Service Action S10148: Retaining Clip, Model Year 2022 XC60 and XC90 PHEV vehicles

GROUP: 2600	CAT/NO: S10148	ISSUING DEPARTMENT: Product, Safety and Compliance	CAR MARKET: United States	
REVISIONS:			ISSUE DATE: 2022-02-11	STATUS DATE: 2022-02-11
Page 1 of 2

Title	Battery cooling system separator hose	Page	1 (4)
Action	Product fix	Operation number:	97808-2

Installation

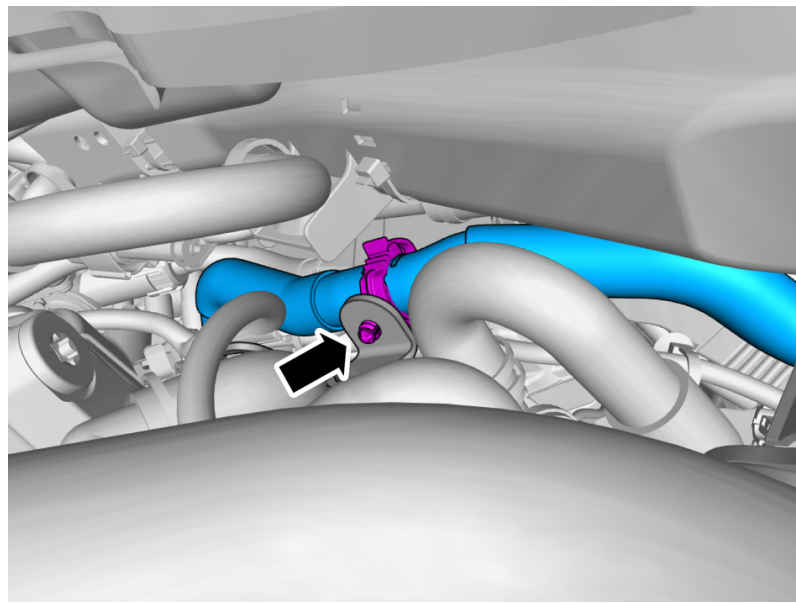
Volvo has identified that over time, there is a risk that there will be wear on the cooling hose that potentially could lead to a refrigerant leak. In worst case scenario, this may lead to customer experiencing reduced charging efficiency and message in Driver Information Module (DIM).

The corrective action is to place a retaining clip on the cooling hose to prevent chafing.

Install the clip(s).
